MODEL R-60

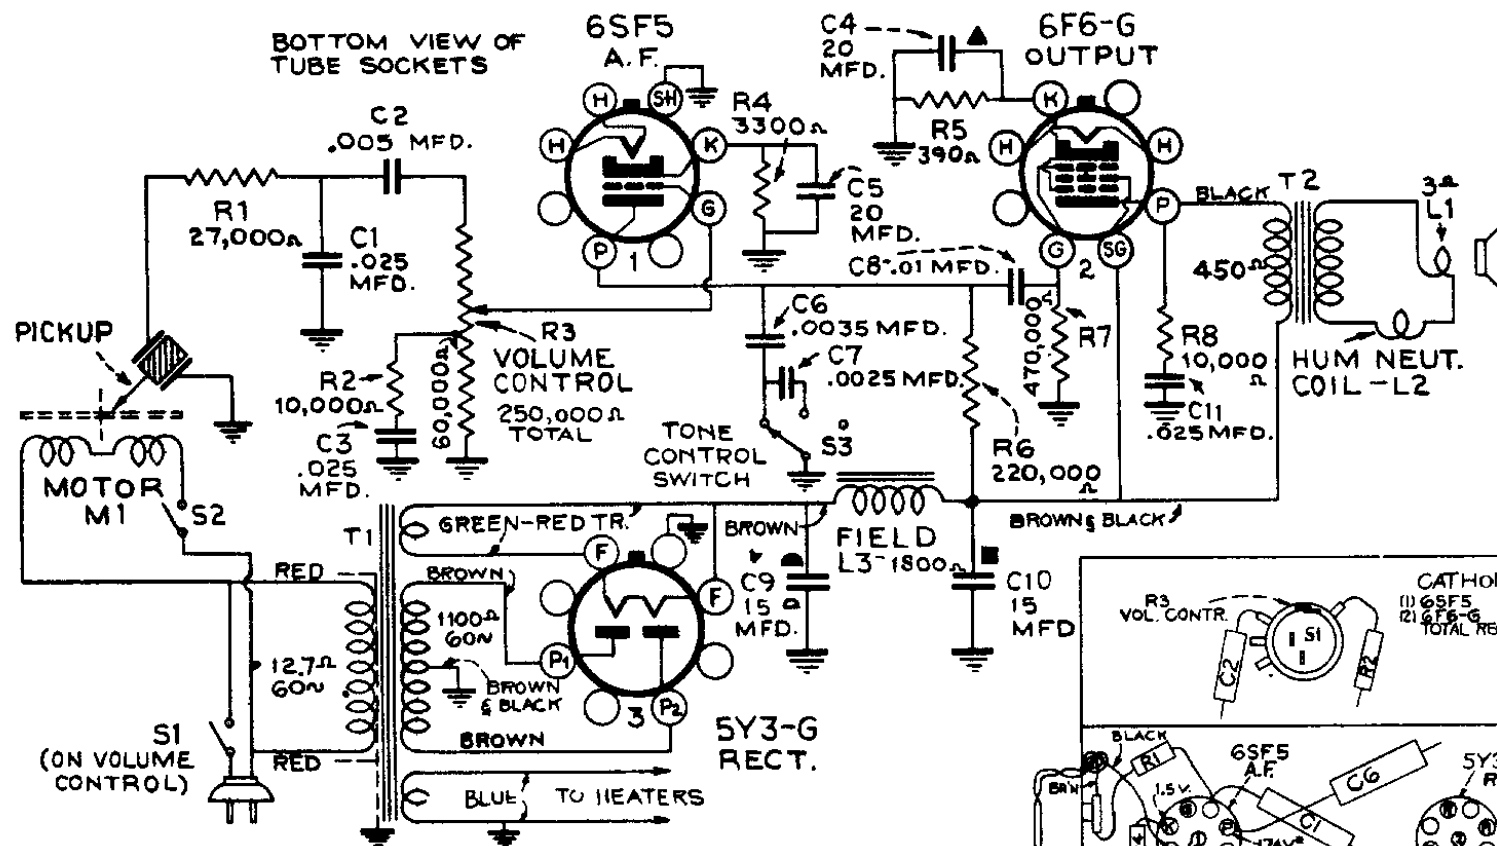
Note: On some receivers the following circuit modifications are in effect:

1. R11 is 4,700 ohms, and C18 is .05 mfd.
2. C1 is 470 mmfd.
3. There are three types of 2nd I-F transformers in use.
 - a. The first type (Stock No. 14308) has C23 and R5 mounted inside the case, and is connected exactly as shown above.
 - b. In the second type R5 is omitted and the lead from S4 connects to C instead of E. E is not used.
 - c. In the third type R5 is omitted and C23 is connected externally from C to ground. E is not used. The lead from the diode plate connects to A instead of B.
